Seismic Walkdown Checklist (SWC)

Equipment ID No. 2-1217-84-00 Equip. Class¹² 21

Equipment Description ACCW HEAT EXCHANGER

Equipment ID No. 2-1302-P4-002 Equip. Class¹² 5

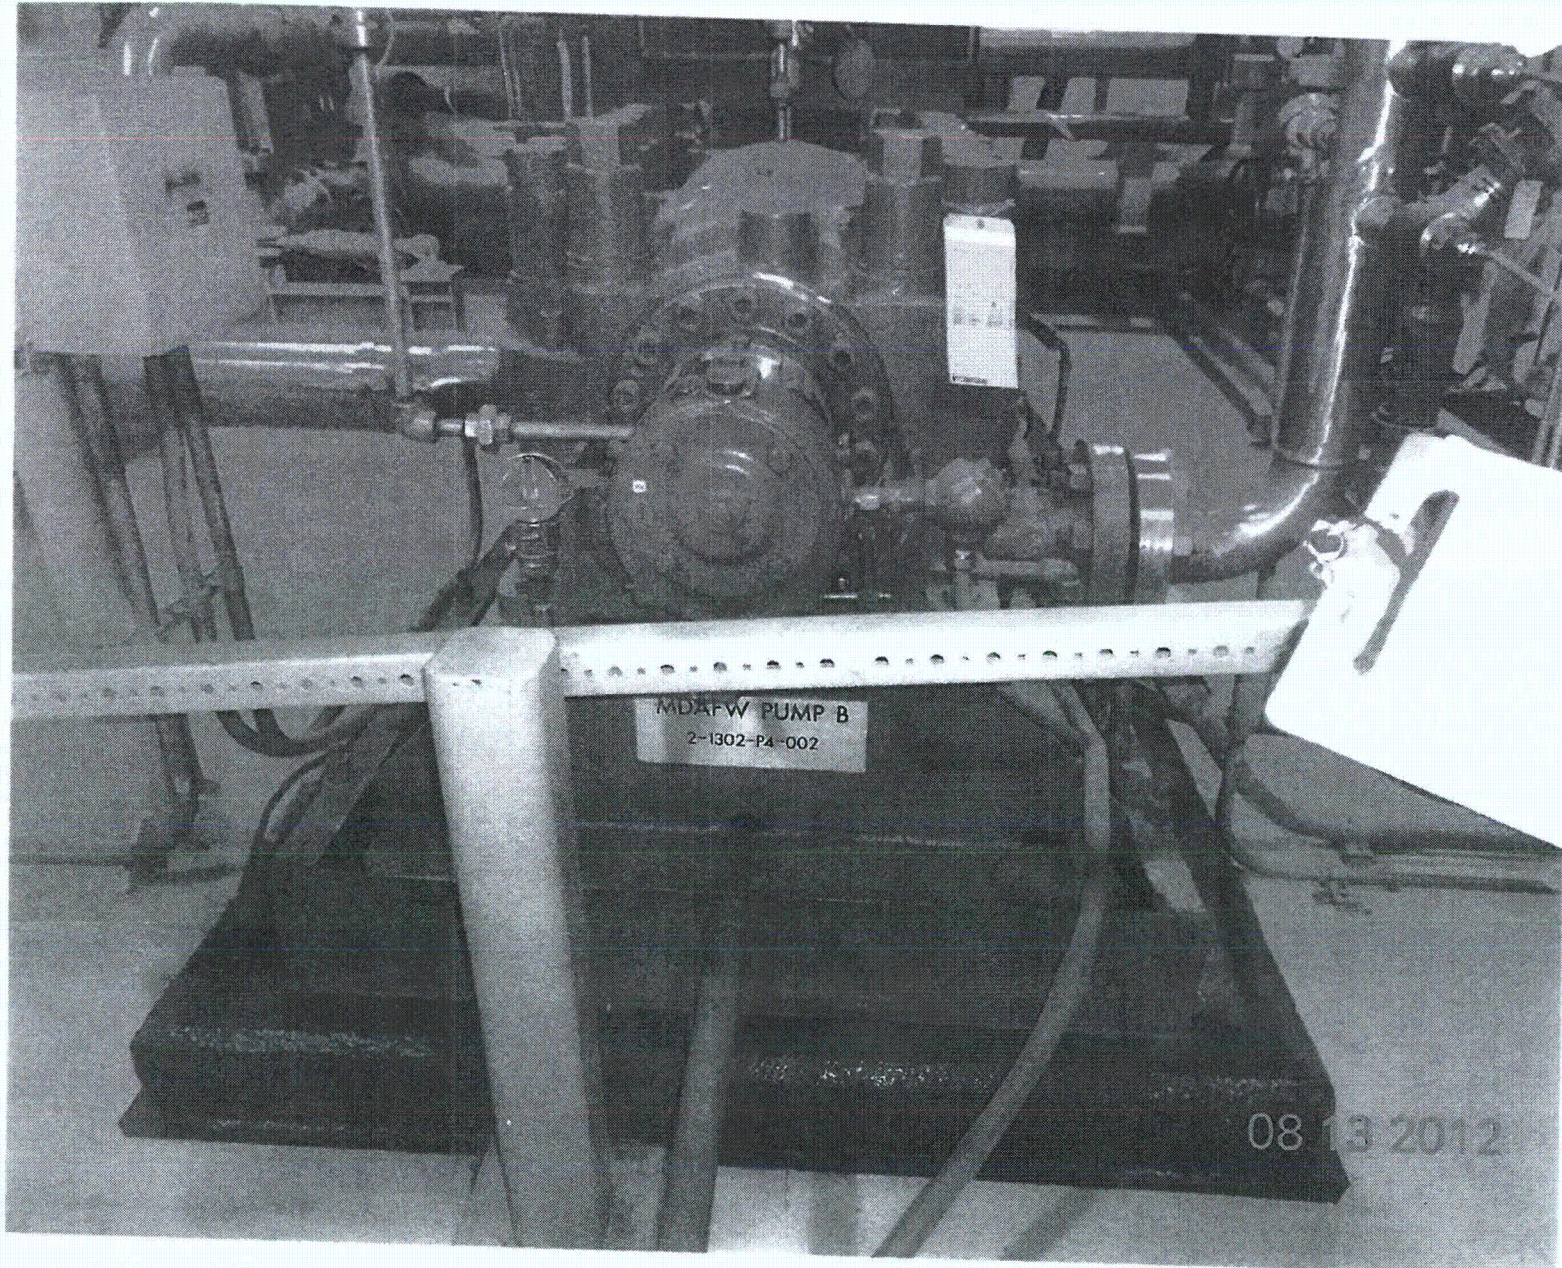
8-13-2012 DV
7. Are soft targets free from impact by nearby equipment or structures? Y N U N/A
USED FOR HOLDING
Bucket held the suspended chain for overhead
monorail is acceptable.

Equipment ID No. 2-1302-V4-001 Equip. Class¹² 21

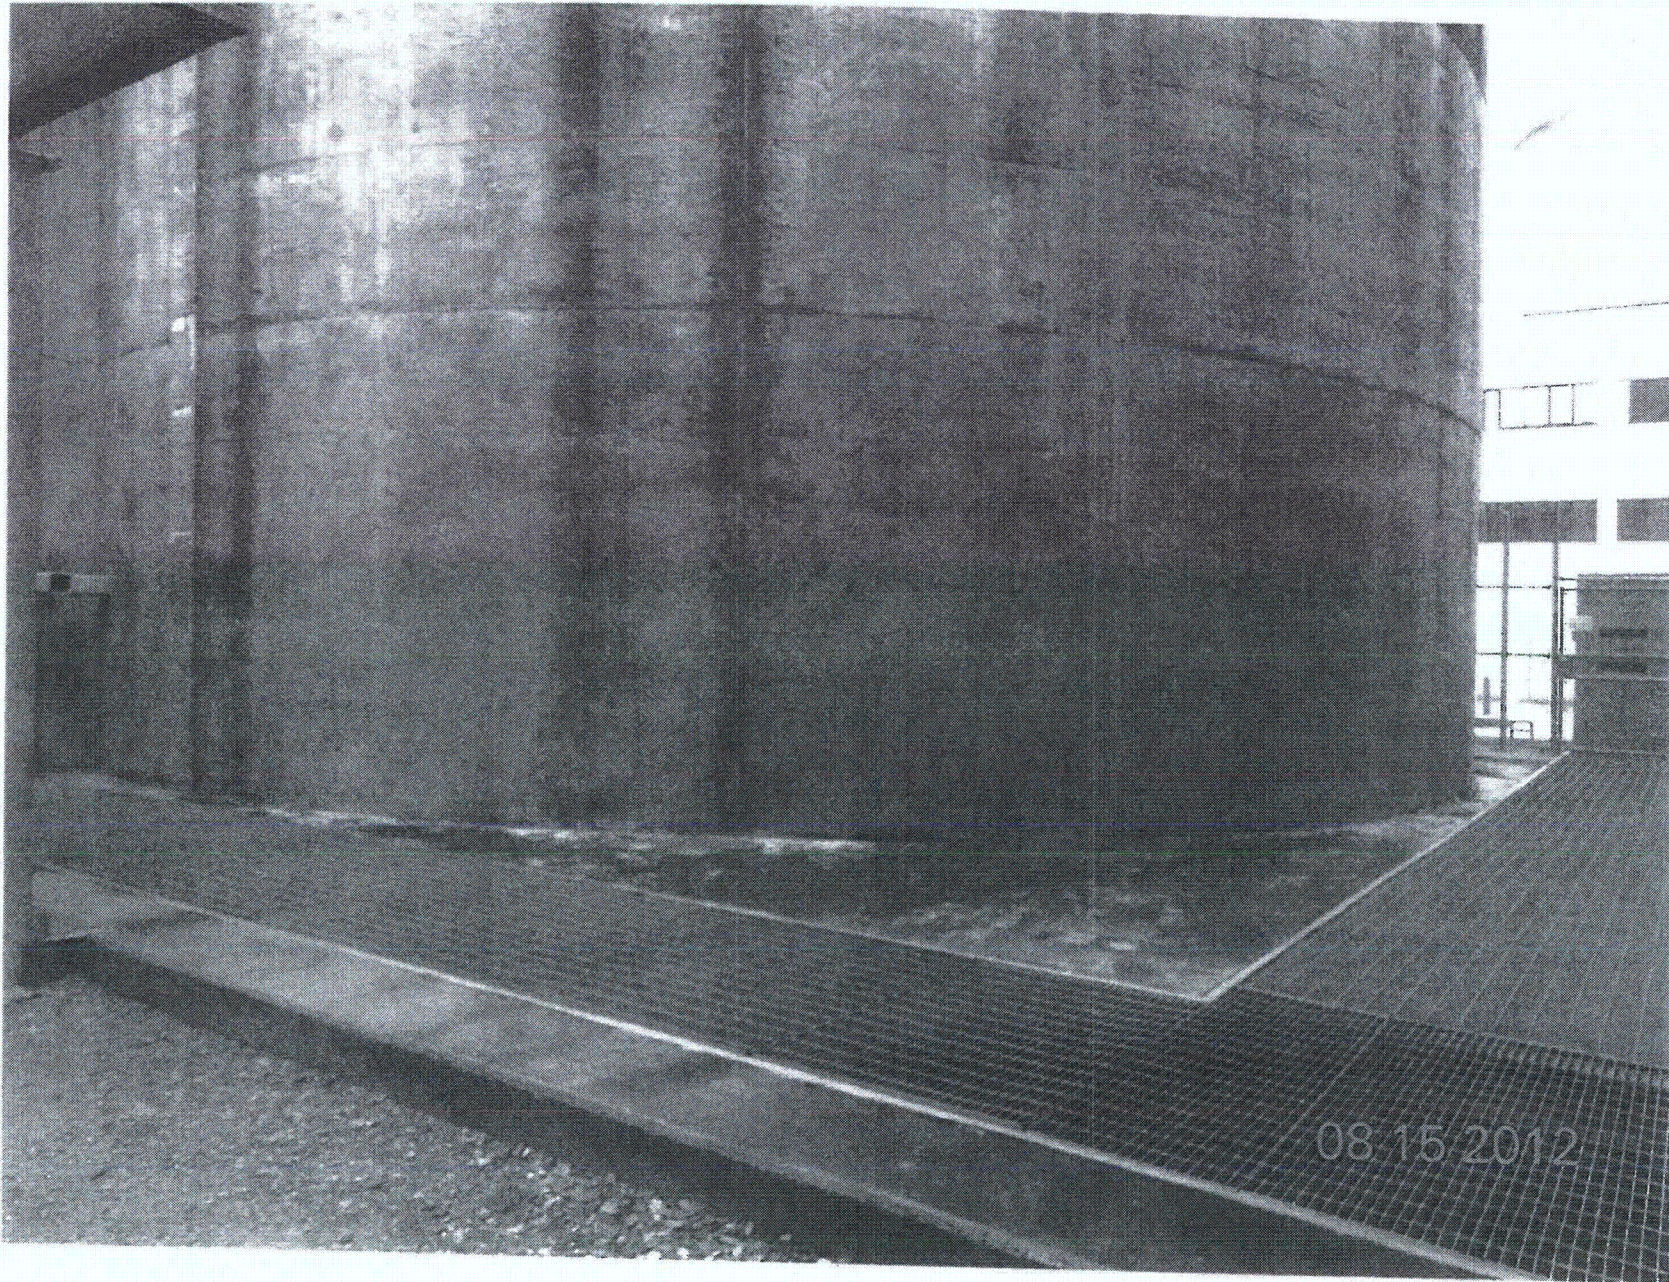
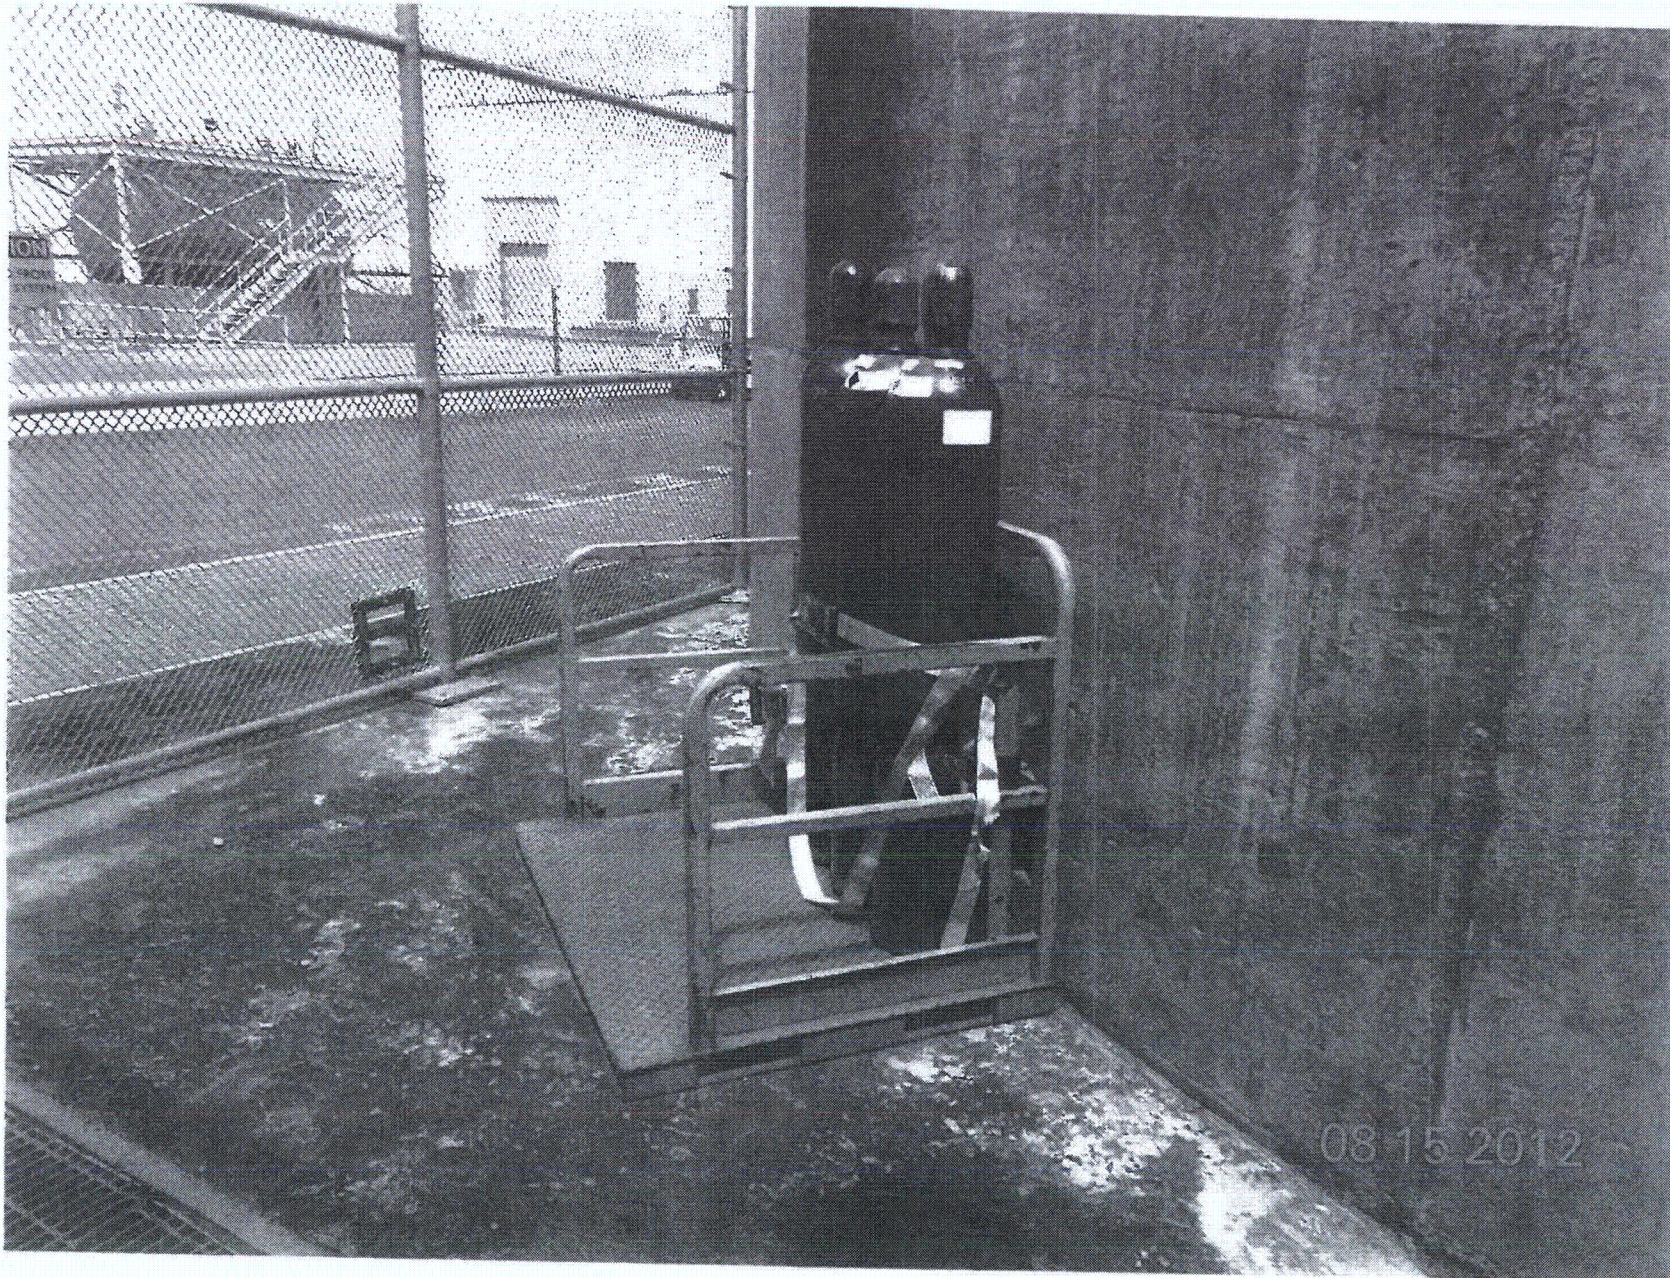
The tank is concrete shell structure. Tank shell on top of concrete foundation has no sign of degradation or structural cracks. The hairline crack is superficial and no effect to the integrity of tank and is acceptable.

Equipment ID No. 2-1540-B7-003-000 Equip. Class¹² 9 - FANS

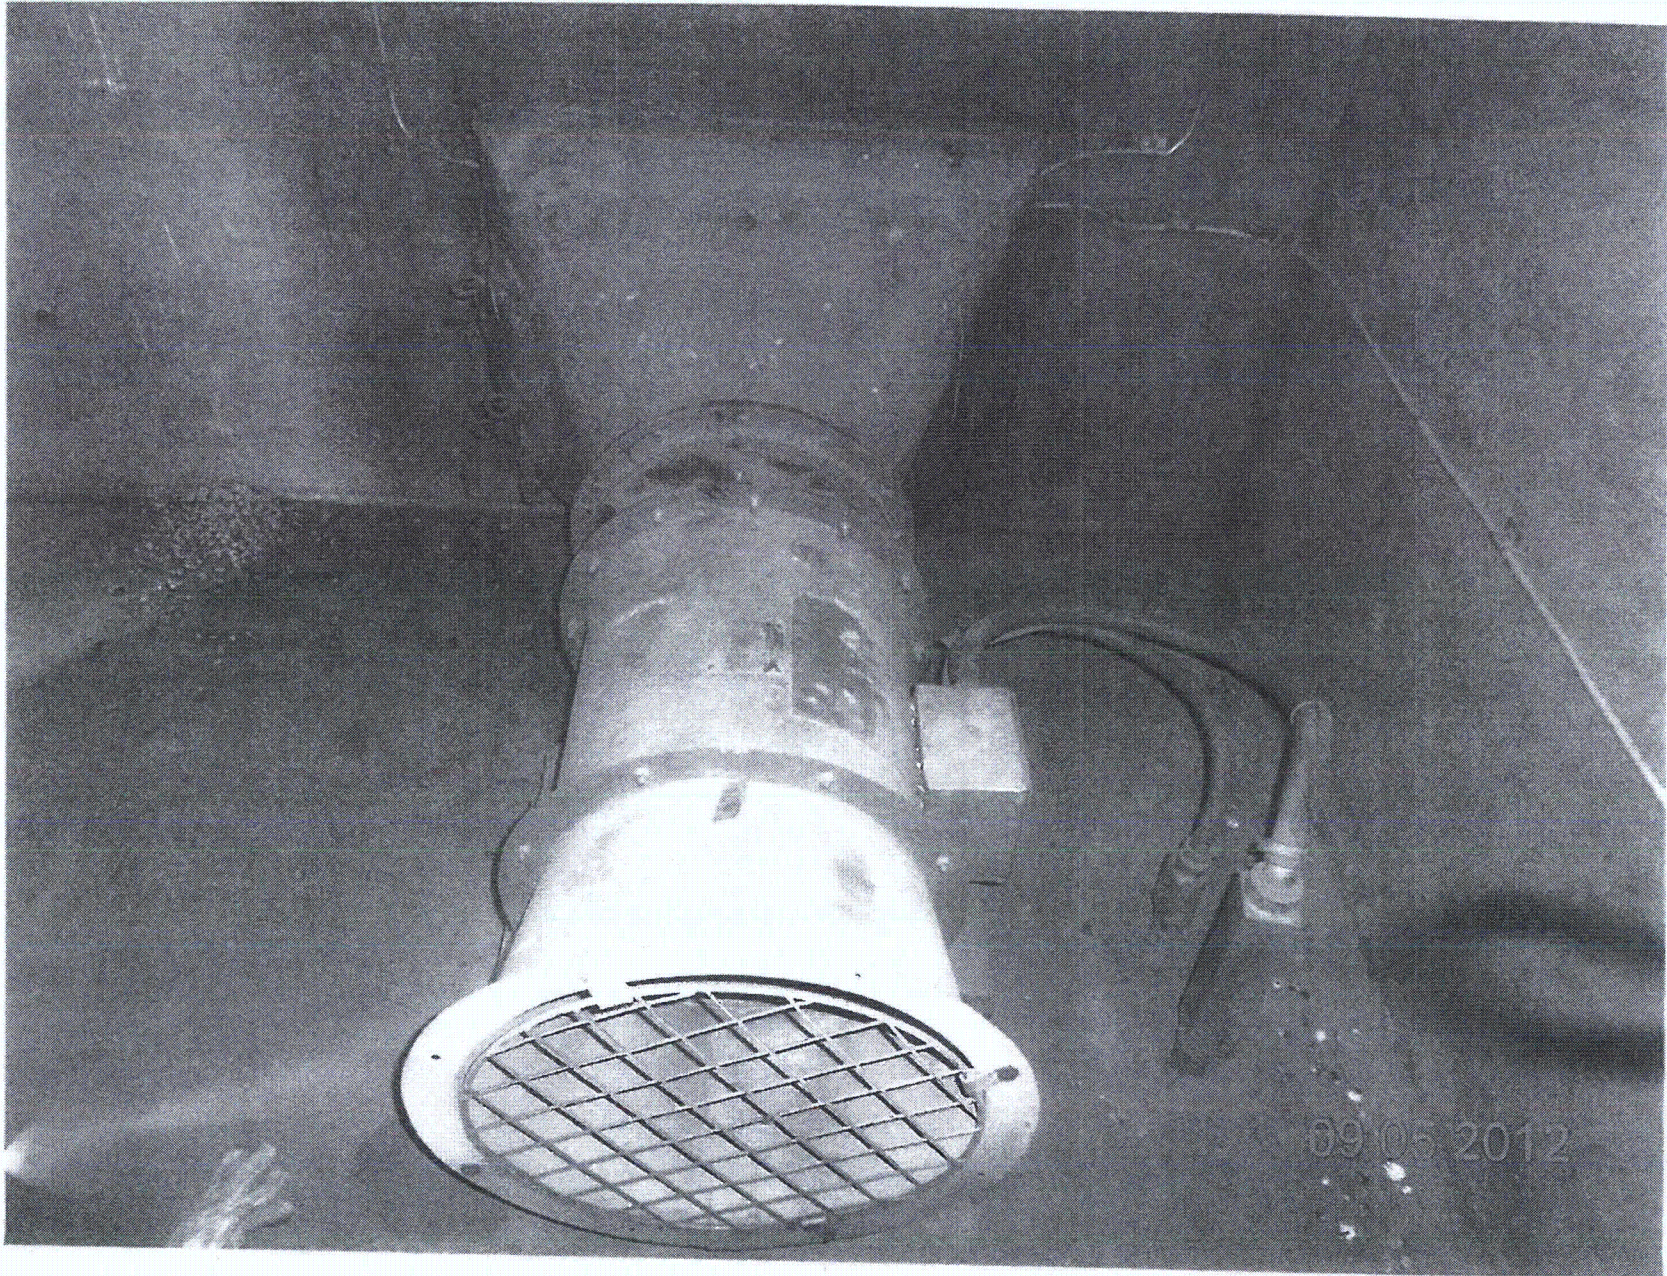
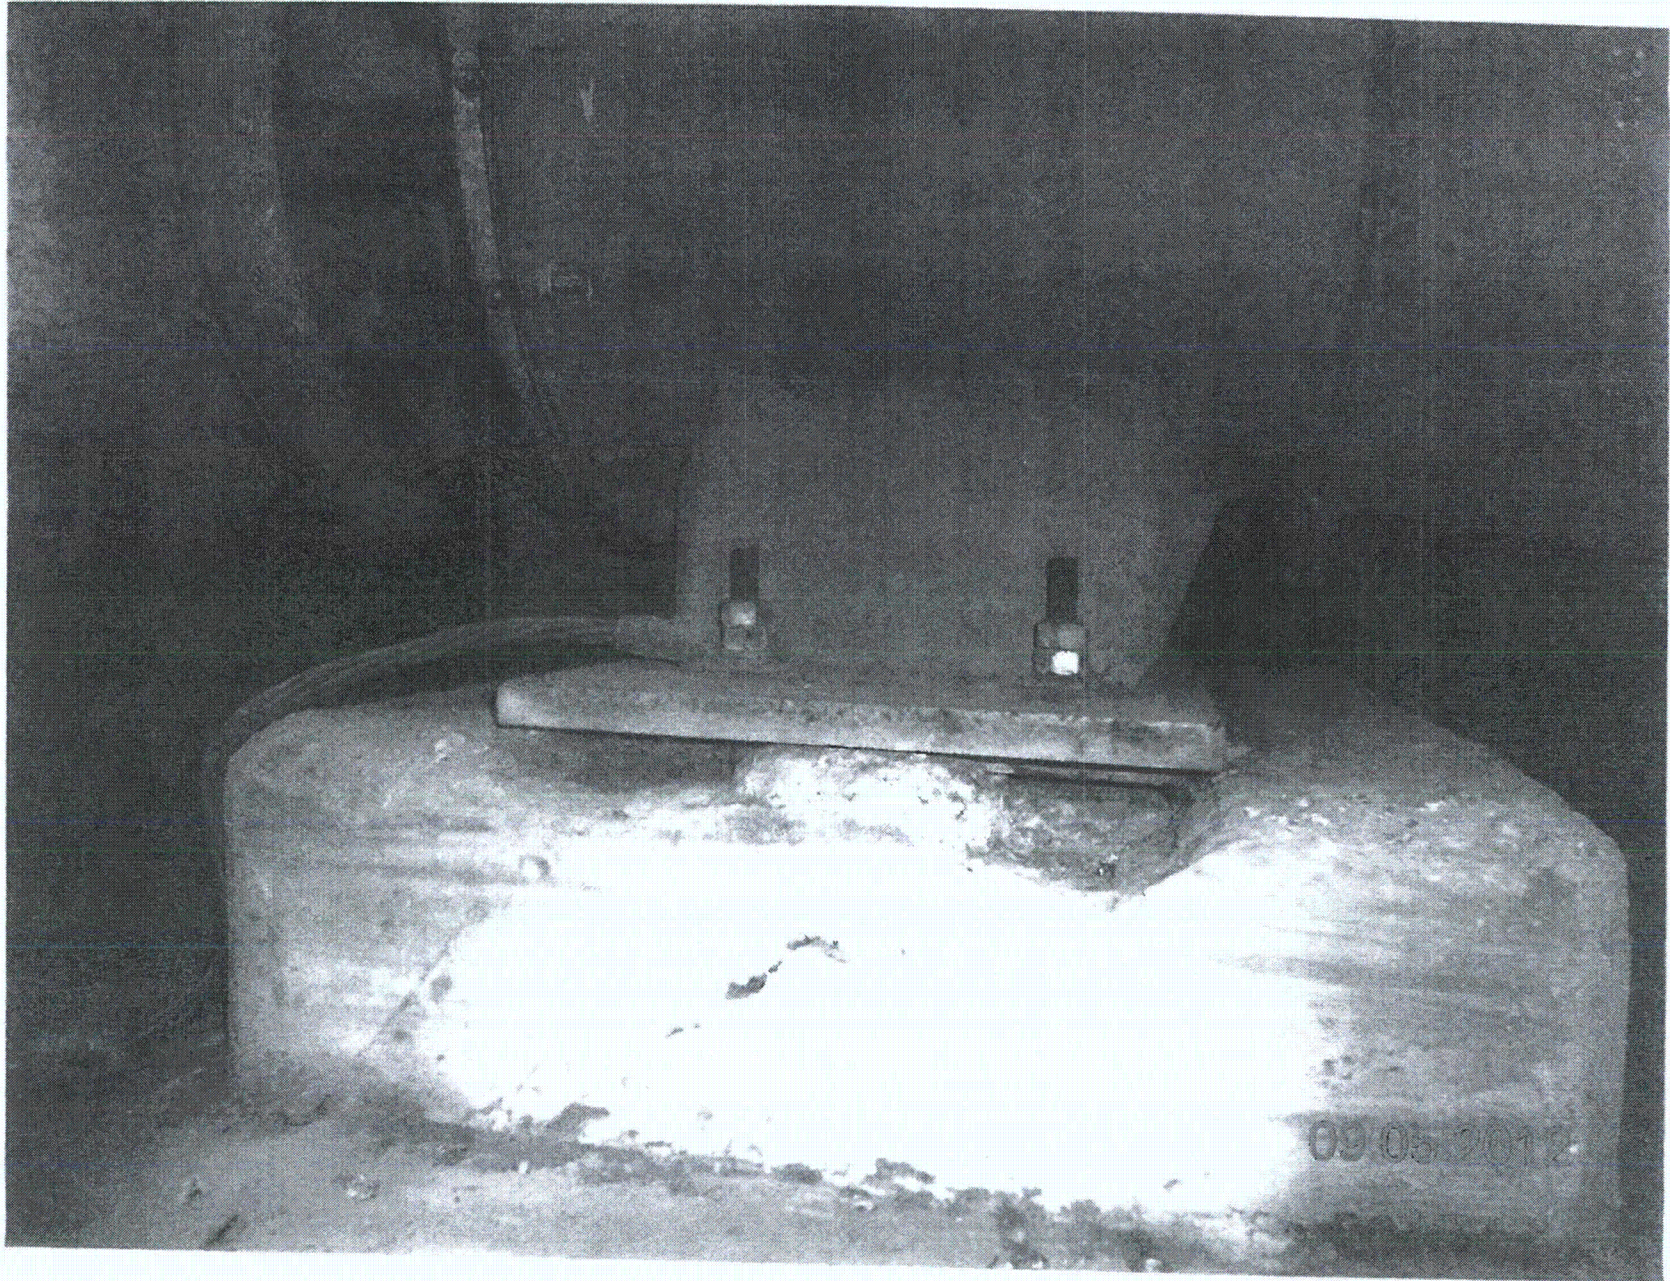
4. Is the anchorage free of visible cracks in the concrete near the anchors? Y N U N/A
*SEE CR # 51338
 Grout was missing on the anchor bolts area. The condition was documented on a CR to initiate action to correct the issue.
 JEH. 10/27/14.*
